Model: Triton-C1		Date: 28-Oct-04	No.: MB186001
Modified Article: Clutch & IC		Prepared by: M. Tsuyuki	
From: 1st Tech. Support Sec. Service Support Dept.			
Reason for Modification:	<input checked="" type="checkbox"/> Parts catalog correction <input type="checkbox"/> To facilitate assembly <input type="checkbox"/> Part standardization	<input type="checkbox"/> Vendor change <input type="checkbox"/> To improve reliability <input type="checkbox"/> Other	<input type="checkbox"/> To meet standards ()

Model: Triton-C1		Date: 7-Dec-04	No.: MB186002
Modified Article: ICs		Prepared by: M. Tsuyuki	
From: 1st Tech. Support Sec. Service Support Dept.			
Reason for Modification:	<input checked="" type="checkbox"/> Parts catalog correction <input type="checkbox"/> To facilitate assembly <input type="checkbox"/> Part standardization	<input type="checkbox"/> Vendor change <input type="checkbox"/> To improve reliability <input type="checkbox"/> Other	<input type="checkbox"/> To meet standards ()

12. By-Pass Feed Unit

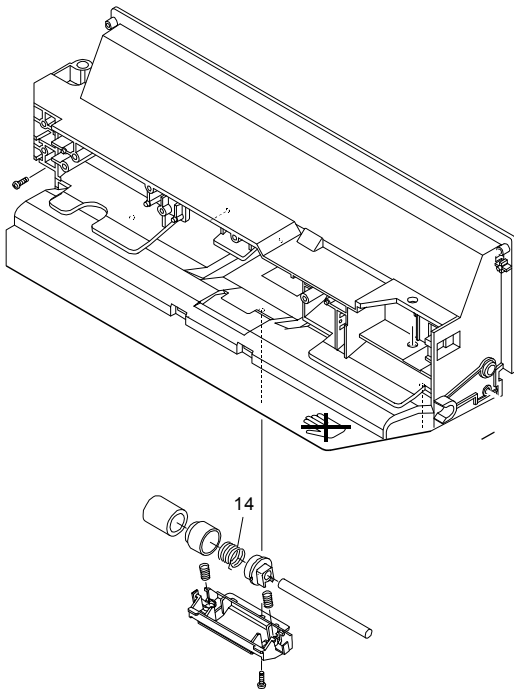
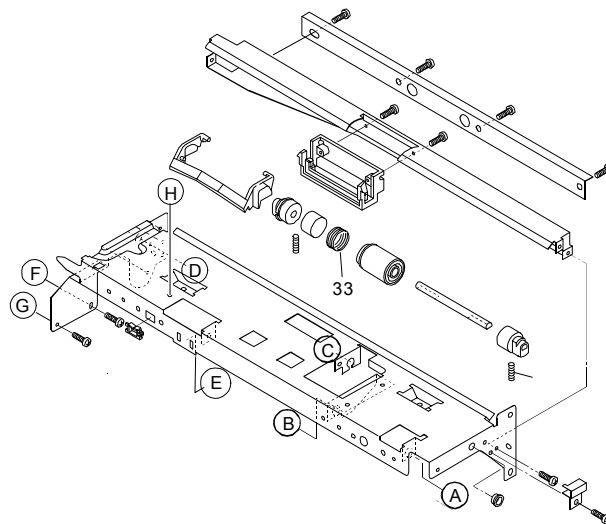
Old part number	New part number	Description	Q'ty	Int	Page	Index
B1862554	B1862054	Spring (4401784210) Spring (4406347650)	2	O/O	25 29	14 33

Change/Reason: Parts standardization with another model.

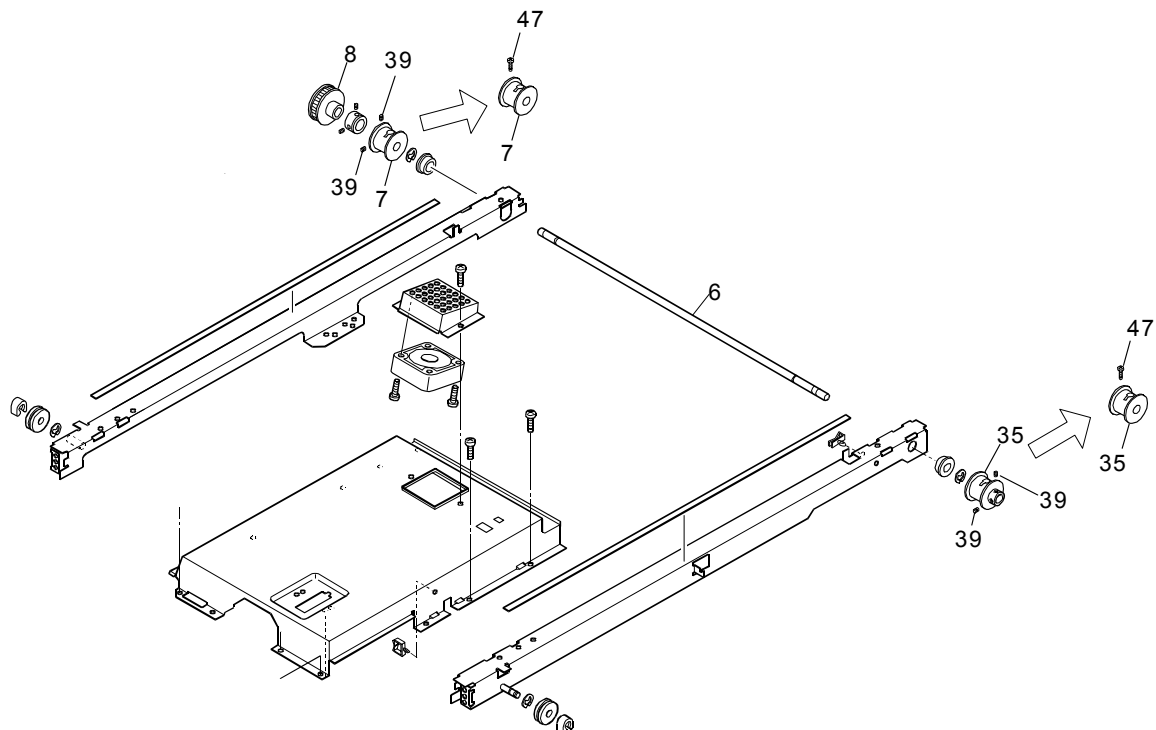
Old part number	New part number	Description	Q'ty	Int	Page	Index
B1861626	B1861686	Scanner Drive Shaft (4406517930) Scanner Drive Shaft (6LA97447000)	1	X/X	9	6
B1861627	B1861687	Rear Wire Pulley (4408634830) Wire Pulley (6LA01742000)	1	X/X	9	7
B1861628	B1861688	Pulley – 24T (4408675410) Pulley – 24T (6LA97448000)	1	X/X	9	8
B1861647	B1861687	Front Wire Pulley (4408634790) Wire Pulley (6LA01742000)	1	X/X	9	35
B1867046	B1867083	Set Screw – M4X6 (X0-00736000) Screw – M3X8 (X0-00077000)	9->5 0->2	X/X	9	39 47

Change: Four set screws in the illustration were deleted, and two pan head screws were added.

Reason: To attach the wire pulley to the shaft more securely.

Note: The interchangeability of the old and new parts is O/O as a set.

24. Fusing Unit 2

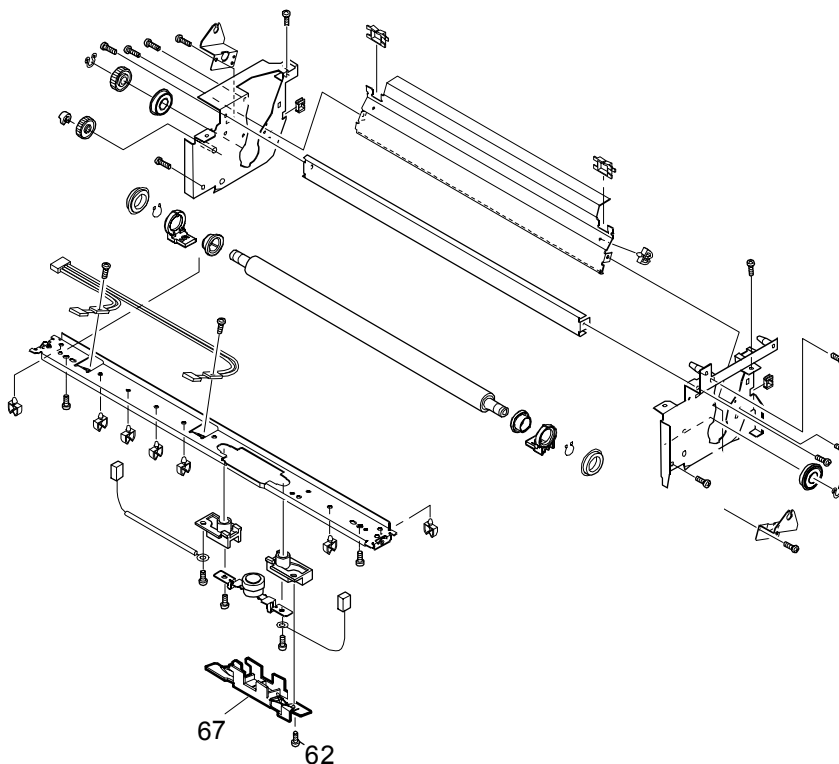
Old part number	New part number	Description	Q'ty	Int	Page	Index
	B1864143	Thermostat Cover (6LA97349000)	1		49	67

Change: A thermostat cover was added.

Reason: To provide for increased work safety during factory assembly.

20. Development Unit 1

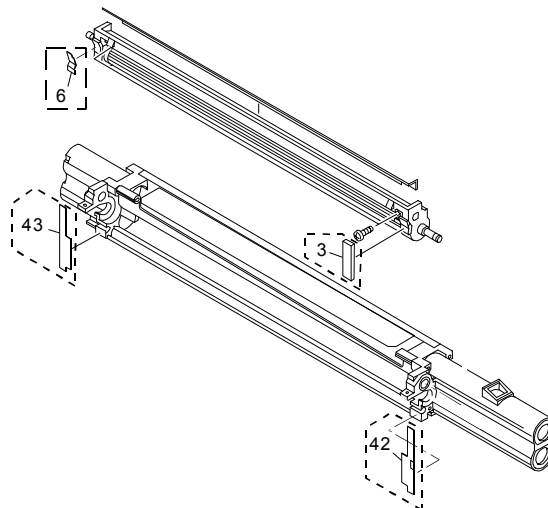
Old part number	New part number	Description	Q'ty	Int	Page	Index
B1863001	B1863081	Development Unit – Y (44218040000) Development Unit – Y (6LA51193000)	1	O/O	41	*
B1863002	B1863082	Development Unit – MCK (44218050000) Development Unit – MCK (6LA51194000)	3	O/O	41	*

Change: The development unit cover (#37), holder (#36) and side seals (#3, 6, 42, 43) were added to the development unit.

Reason: To facilitate assembly in the field.

5. Scanner Unit 2

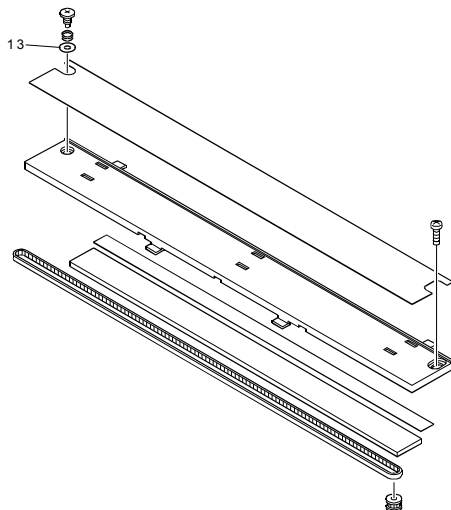
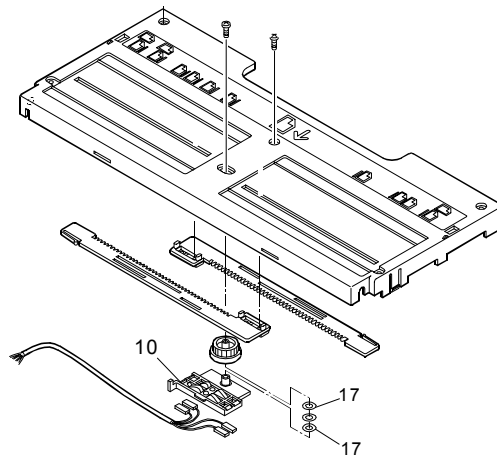
Old part number	New part number	Description	Q'ty	Int	Page	Index
B1862581	B1862081	Pinion Holder (44218419000) Pinion Holder (6LA78990000)	1	O/O	23	10
B1867010	B1867084	Washer (4842040454) Washer (6LA78908000)	2 1	O/O	23 11	17 13

Change/Reason: Parts number standardization by the machine vendor.

26. Transport Belt Unit 1

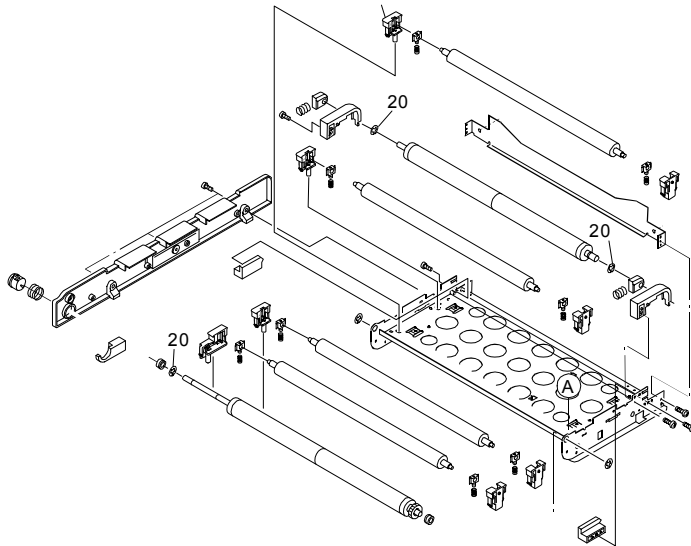
Change/Reason: The Parts Catalog was corrected as follows.

Old part number	New part number	Description	Q'ty	Int	Page	Index
B1864501		Plate (44218264000)	3->0		53	20

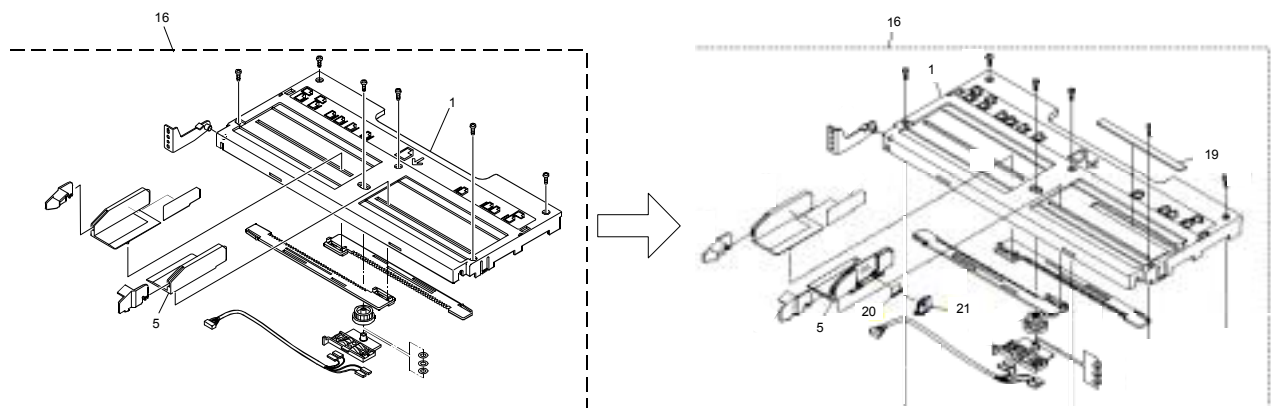
Change: The following parts were added or changed.

Reason: To make it easier for the paper guides to hold the paper in place.

Old part number	New part number	Description	Q'ty	Int	Page	Index
B1862471	B1862371	Table Ass'y (6LE72972000)	1	X/X	23	16
B1862572	B1862472	By-pass Table (6LA51161200)	1	X/O	23	1
B1862576	B1862476	Front Paper Guide (6LE72981000)	1	X/X	23	5
	B1862486	Guide Sheet (6LE2982000)	1		23	19
	B1862487	Guide Lever (6LA79104100)	1		23	21
	B1862488	Guide Spring (6LA79105000)	1		23	20
B1862590	B1862490	Feed Frame (6LE72971000)	1	X/O	25	1
	B1862489	SP Table Ass'y (6LE72970000)	1		23	*
